# INNER WEST COUNCIL

## DEVELOPMENT ASSESSMENT REPORT

<b>Application No.</b>	DA201600565.01
<b>Address</b>	595 King Street, Newtown
<b>Proposal</b>	Section 82A review of Determination No. 201600565, dated 8 May 2017, to retain the front façade and ground floor shop and construct a 4 storey development comprising 1 commercial tenancy and 5 residential units
<b>Date of Lodgement</b>	12 July 2017
<b>Applicant</b>	JRU Partnership
<b>Owners</b>	JLV Properties Pty Ltd & Romeli Property Group Pty Ltd & Unicorn Projects Pty Ltd
<b>Number of Submissions</b>	46 submissions including a petition containing 3,871 signatures.
<b>Value of works</b>	\$1,495,000
<b>Reason for determination at Planning Panel</b>	Clause 4.6 variation to maximum floor space ratio development standard; number of submission received; and exceeds officer delegation as there is no substantial change to the recommendation of the review
<b>Main Issues</b>	Excessive floor space ratio
<b>Recommendation</b>	Refusal

Image 1: Rear building envelope

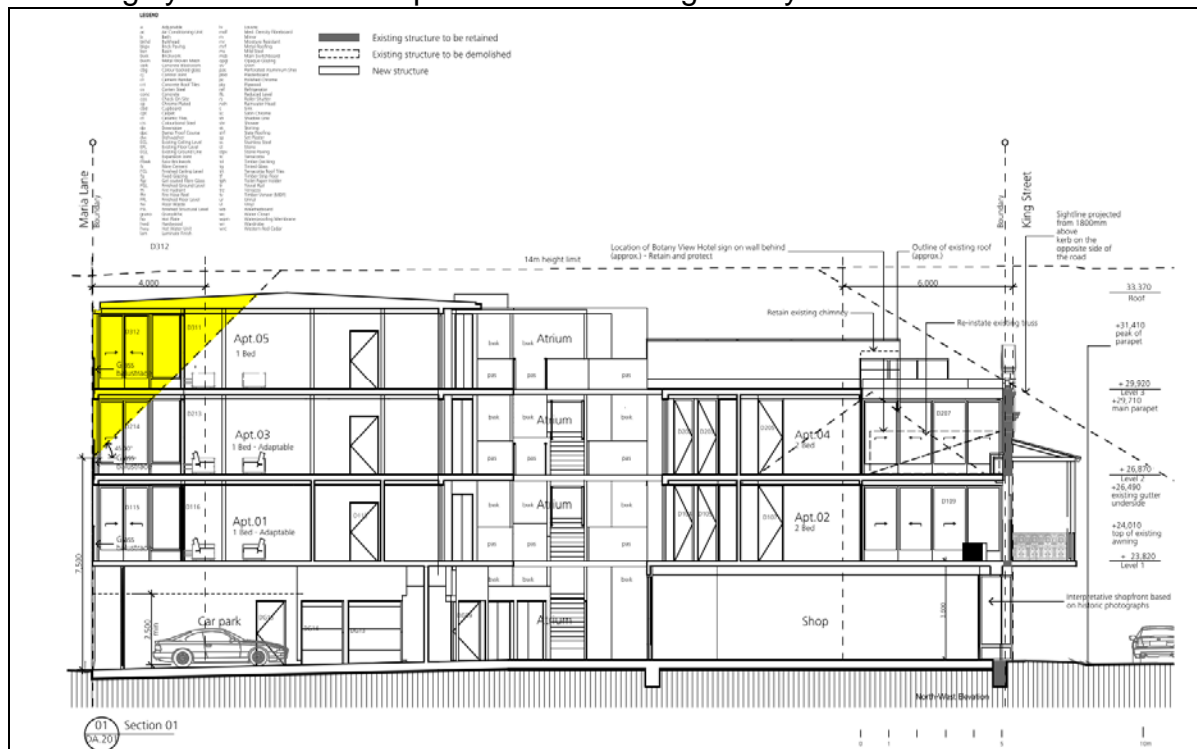
- I. The rear building envelope must be contained within the combination of the rear boundary plane and a 45 degree sloping plane from a point 7.5 metres vertically above the lane ground level, measured at the rear boundary, and contain a maximum of two storeys on the rear most building plane;*
- II. Notwithstanding point i., building envelopes may exceed the above building envelope control where it can be demonstrated that any rear massing that penetrates above the envelope control will not cause significant visual bulk or amenity impacts on neighbouring properties to the rear;*
- III. The rear building envelope must contribute positively to the visual amenity of the laneway, and encourage rear laneway activation through measures such as providing appropriate lighting and opportunities for passive surveillance.”*

As indicated in the image below, the development has a maximum height at the rear boundary of 12.2 metres and four storeys. This is a significant breach of the rear building envelope controls. Whilst it is acknowledged that there are examples of rear building envelopes in the locality that do exceed the 2 storey limit, the 4 storeys proposed is considered to be excessive and out of character with the locality and results in significant visual bulk to the low density streetscape to the west. The four

storey form does not contribute positively to the visual amenity of the laneway and will be highly visible from the public domain along Darley Street to the south west.
